Subject: Beaver Valley Power Station, Unit Nos. 1 and 2 BV-1 Docket No. 50-334, License No. DPR-66 BV-2 Docket No. 50-412, License No. NPF-73 Supplement to License Amendment Request Nos. 327/197 (Unit No. 1 TAC No. MC4649/Unit No. 2 TAC No. MC4650), 317/190 (Unit No. 1 TAC No. MC3394/Unit No. 2 TAC No. MC3395) and 320 (Unit No. 1 TAC No. MC6725)

Beaver Valley Power Station, Unit Nos. 1 and 2 Supplement to License Amendment Requests 327/197, 317/190 and 320 L-05-163 Page 2

### **FENOC Evaluation of the Proposed Supplements**

BEAVER VALLEY - UNIT 2

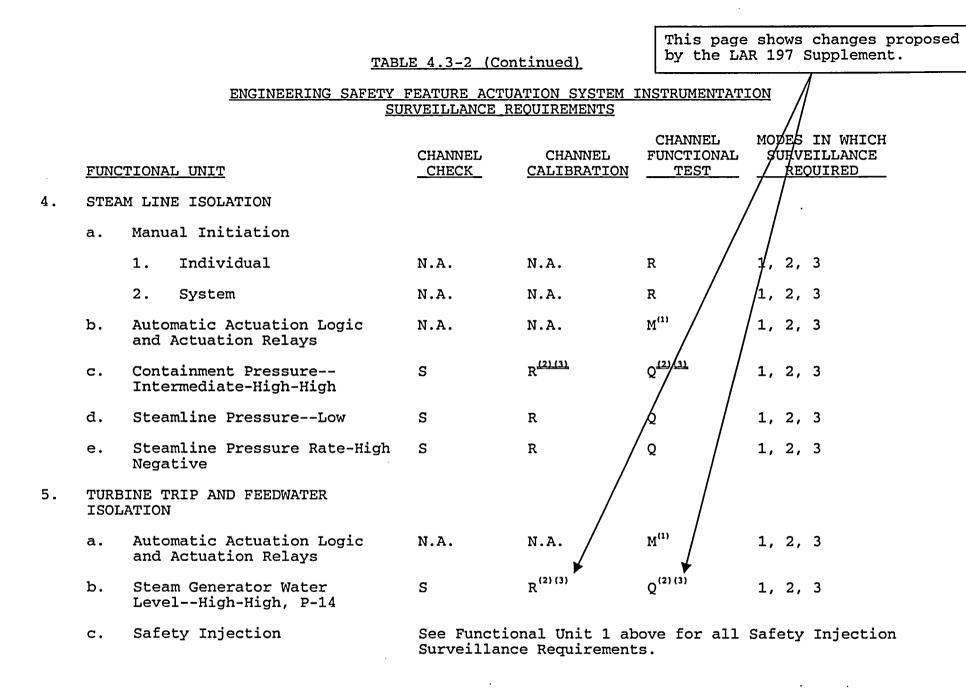
FUNC	TIONAL UNIT	CHANNEL CHECK	CHANNEL CALIBRATION	CHANNEL FUNCTIONAL TEST	MODES IN WHICH SURVEILLANCE REQUIRED
1.		TY INJECTION AND FEEDWATER				
	a.	Manual Initiation	N.A.	N.A.	R	1, 2, 3, 4
x	b.	Automatic Actuation Logic and Actuation Relays	N.A.	N.A.	M <sup>(1)</sup>	1, 2, 3, 4
	c.	Containment Pressure-High	S	R <sup>(2)(3)</sup>	Q <sup>(2)(3)</sup>	1, 2, 3
	d.	Pressurizer PressureLow	S	R	Q	1, 2, 3
	e.	Steam Line PressureLow	S	R	Q	1, 2, 3
1.1		TY INJECTION-TRANSFER FROM CCTION TO THE RECIRCULATION				
	a.	Automatic Actuation Logic Coincident with Safety Injection Signal	N.A.	N.A.	M <sup>(1)</sup>	1, 2, 3, 4
	b.	Refueling Water Storage Tank Level-Extreme Low	S	R <sup>(2)(3)</sup>	Q <sup>(2)(3)</sup>	1, 2, 3, 4
